THE UNIVERSITY OF TEXAS AT AUSTIN

Nuclear Engineering Teaching Laboratory • <http://www.me.utexas.edu/~netl>

Ref: Letter of March 28 2008 (ML080920755) Docket 50-602

Subject: Request to withdraw previous Technical Specification change request and submission of new change request.

6.1.1 Structure

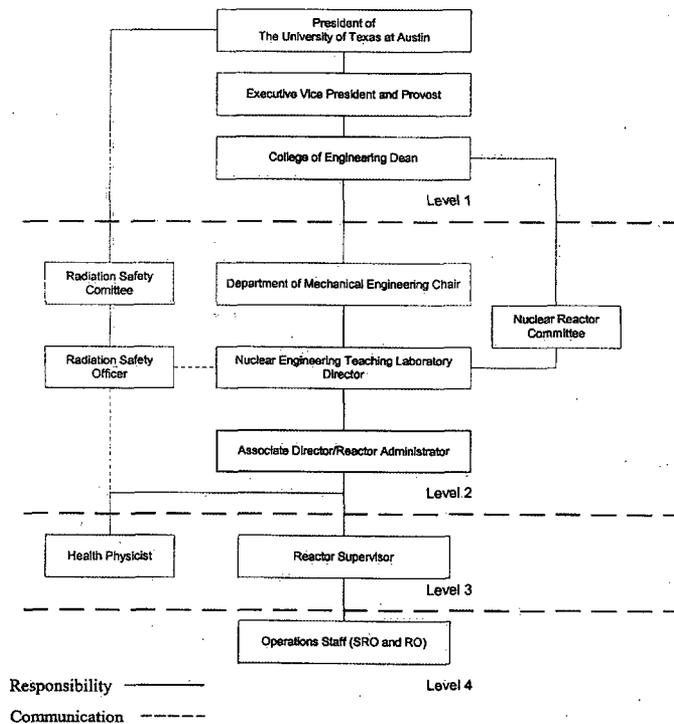
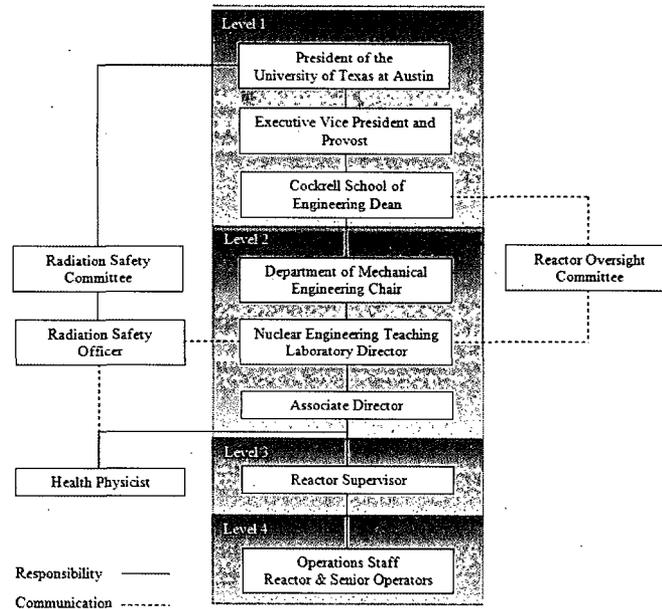
In 2001 a change to the Technical Specifications provided an organizational chart that included line management for reactor operations integrated with radiation safety and oversight functions. The arrangement of labels for Level 1 and Level 2 personnel did not clearly delineate between line management and oversight responsibilities, and the committee tasked with oversight of facility safety is labeled Nuclear Reactor Committee (the name Reactor Oversight Committee is being used internally to avoid confusion in using committee initials). These changes are strictly administrative in nature.

The facility shall be under the control of the Director, Associate Director or a delegated Senior Reactor Operator. The management for operation of the facility shall consist of the organizational structure as follows:
